TO: WECC REMWG
FROM: POUYAN POURBEIK, PEACE®
SUBJECT: PROPOSAL FOR NEW REPC_E POWER PLANT CONTROLLER MODEL
DATE: 8/15/25 (REVISED 9/9/25; 1/23/26; 1/26/26)
CC: D. RAMASUBRAMANIAN, EPRI

REPC_E (new model)

Figure 1: REPC_E model (approved specification from September 2025)

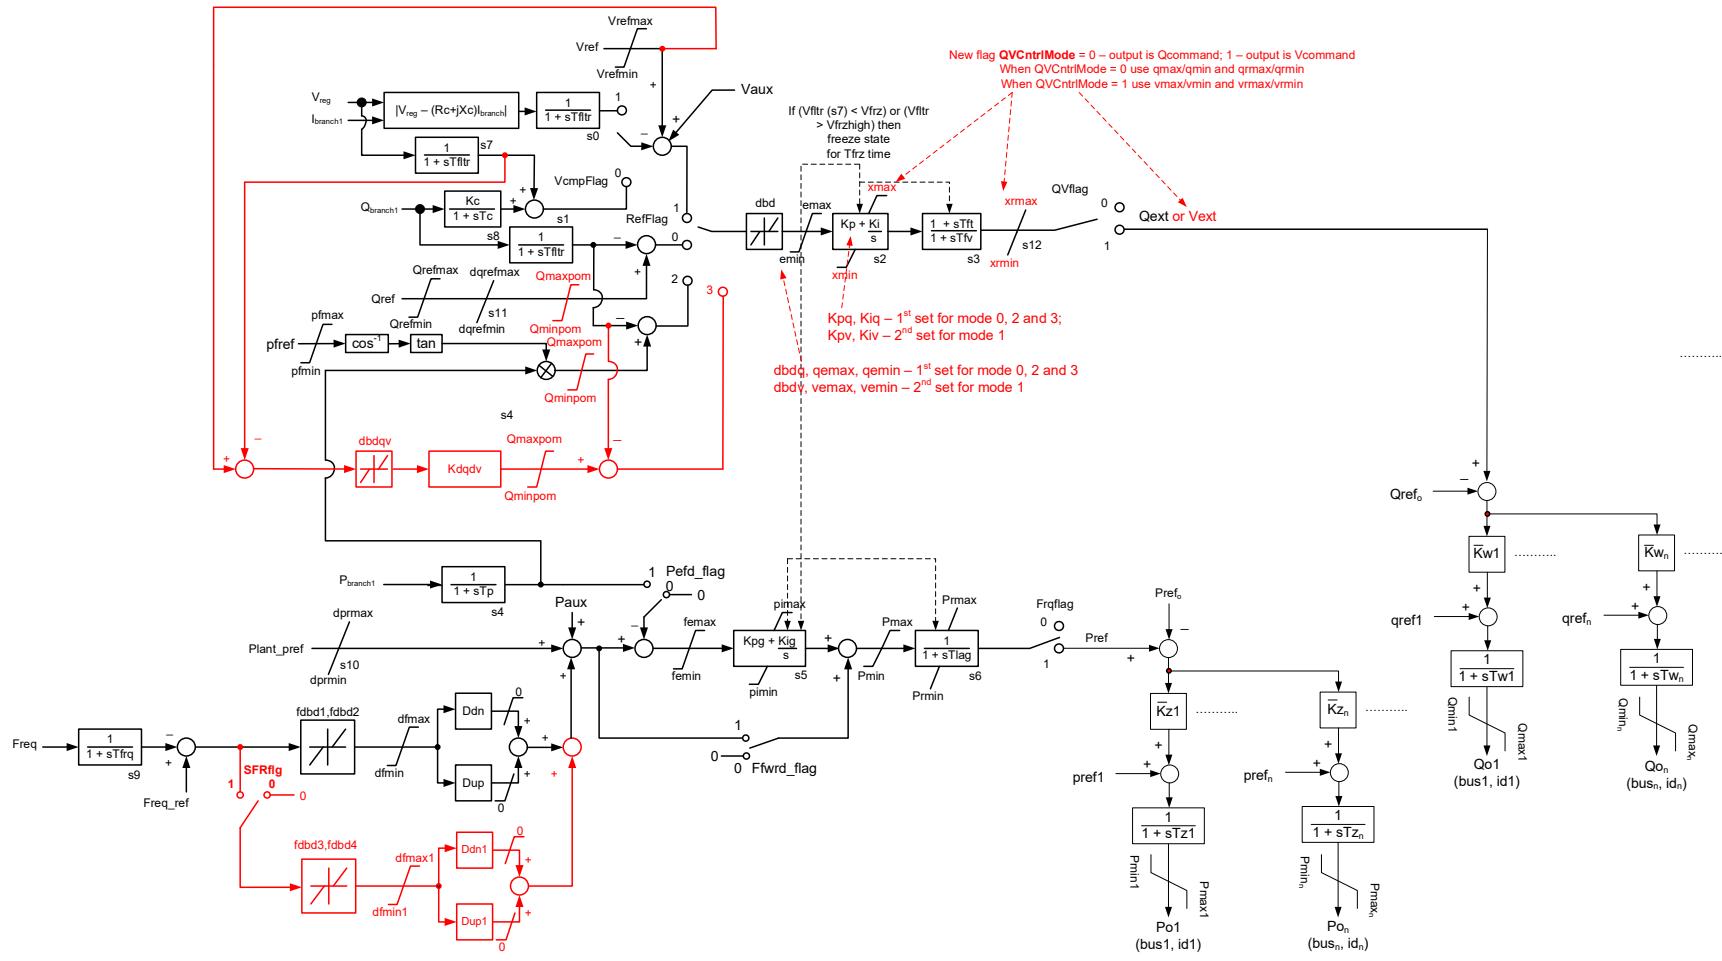
1. **Gains:** adding two pairs of K_p/K_i gains for the reactive controller loop. The model will then automatically switch between the gain pairs depending on the setting of the flag *RefFlag*. See Table 1 and Figure 1.

2. **VQ-droop:** adding a new VQ-droop control option as *RefFlag* = 3. In this control option the voltage error is passed through a symmetrical deadband of $\pm dbdqv$ and then multiplied by a VQ-droop gain K_{dqdv} to get the Q setpoint that is compared with the measured POI branch Q and then fed into the PI control loop.

3. **SFR:** add a Secondary Frequency Response (SFR) loop, which can be enabled/disabled using the new flag *SFRflg*. The SFR control loop has its own deadband (*fdbd2,fdbd4*), error limits (*dfmax1,dfmin1*) and its own droop gains (*Ddn1,Dup1*).

4. **The output limits:** A new flag *QVCntrlMode* should be added so that the user can define whether the downstream aggregated inverters are all to receive a Q-command or a V-command. Then based on that choice the main reactive control loop state is initialized to a Q-command or V-command (*Vext*) and the respective limits (*xmax/xmin* and *xrmax/xrmin*) are set to either the Q limits (*Qmax/Qmin* and *Qrmax/Qrmin*) or the V limits (*Vmax/Vmin* and *Vrmax/Vrmin*). Associated with this addition, this PPC model should be able to interface with all existing generic inverter models, namely: REEC_A, REEC_C, REEC_D, REEC_E, REGFM_A1 and REGFM_B1.

5. ***Qmaxpom/Qminpom:*** Two new parameters, *Qmaxpom/Qminpom* have been added to the model and limit (see Figure 1) the Q setpoint calculated by each of the three (3) different Q-control paths. In this way, this limit can act to limit the max/min Q injected by the PPC at the point of measurement (POM), which is the Q measured on the defined measurement branch. To disable the limits, they may be set to 999/-999.

Figure 2: REPC_E model with proposed new additions as of December 2025 (proposed additions shown in **BLUE** and provided by Tesla)

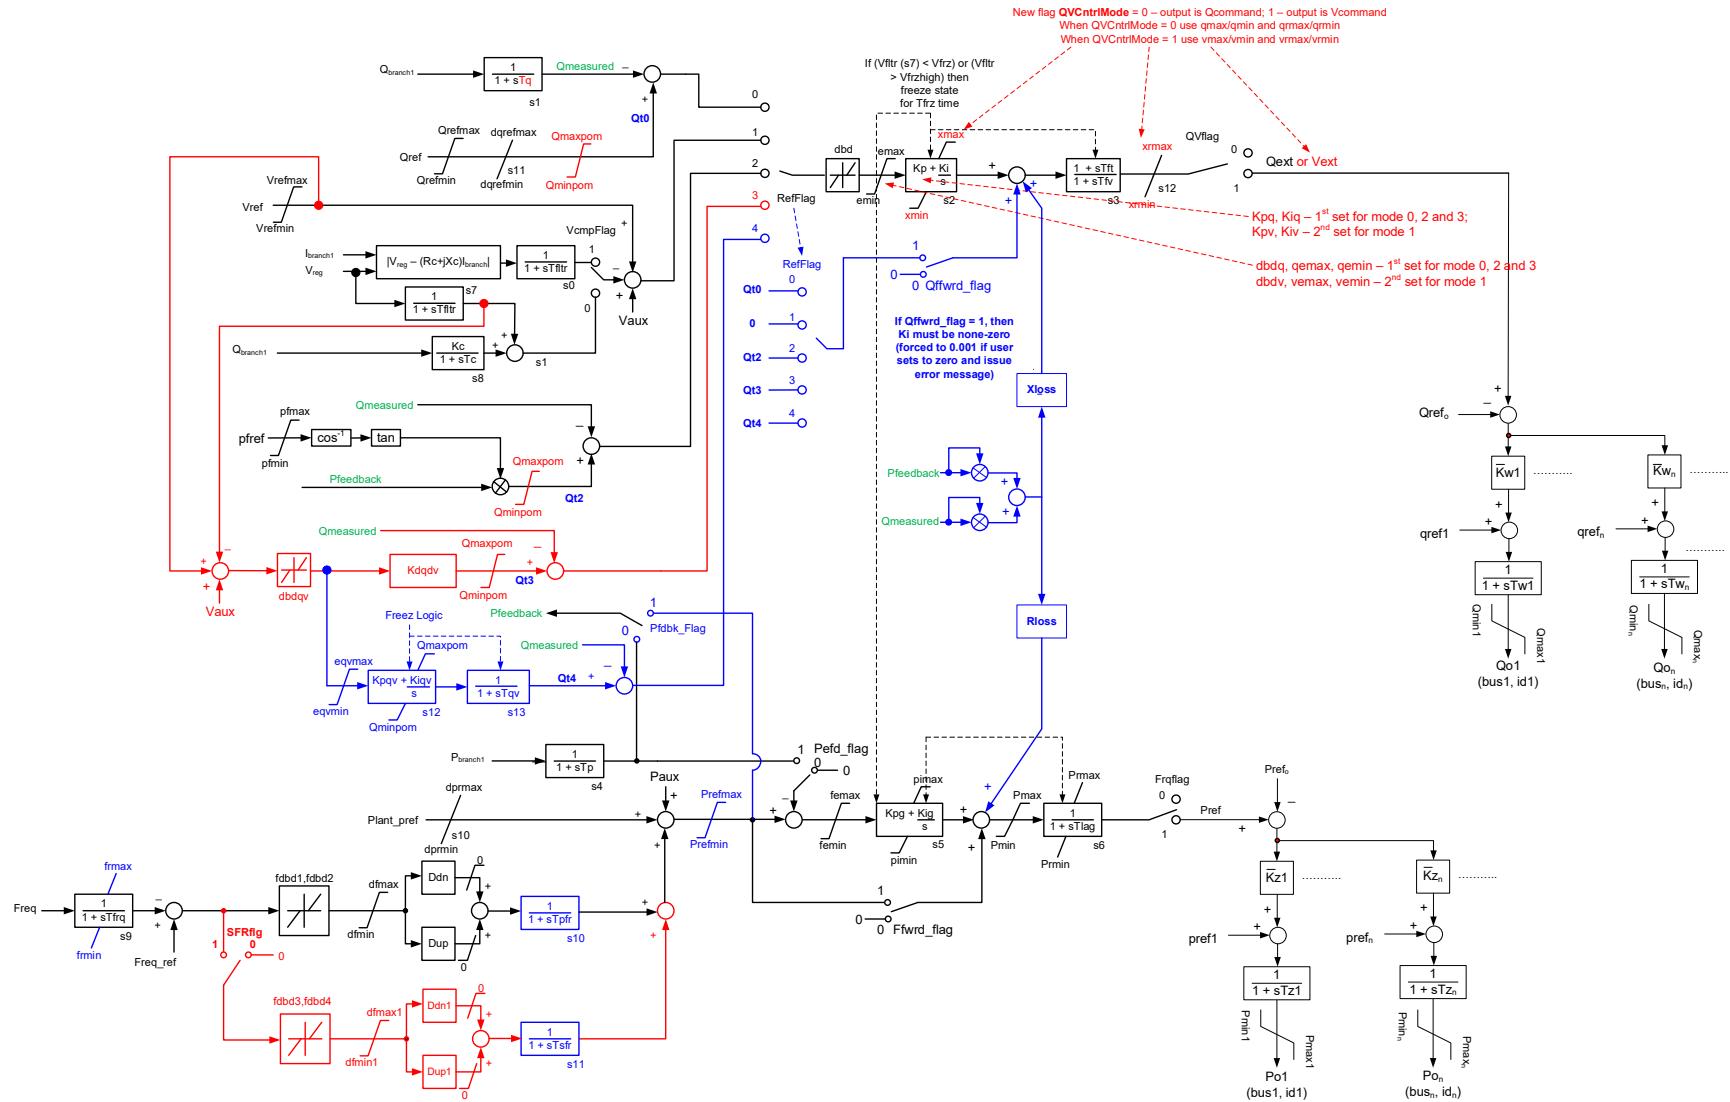
In December 2025, some additional comments were received from Tesla (Sai Gopal Vennelaganti and Fatemeh Sharifi). Those proposed additions are now shown herein in Figure 2. The additions can be briefly explained as follows:

- Adding a few more time constants (to PFR and SFR) and a rate limit to the frequency measurement. These can be used or disabled by the user (i.e. set time-constants to zero and rate limit to a very large number).
- The addition of yet another fourth control path for reactive power, where a double PI strategy is employed (RefFlag = 4)

- The addition of a feedforward path for the reactive power control – it should be noted that if the feedforward path is used, then the main PI controller (K) cannot be zero. If it is set to zero by the user then it should be forced to a small default value (e.g. 0.001) and the user warned of their error.
- The addition of a loss calculation using two parameters (R_{loss} and X_{loss}) which can be set to zero to disable their use. These paths essentially can be used to estimate collector system P and Q losses, and thus adding them into the P and Q control path to compensate for the losses. **Aside Note:** the standard PI loops in essence already do this, and so these additions are not necessary to compensate for losses. However, some vendors may use this strategy so that the PI loop outputs correspond more directly to the P/Q target values.
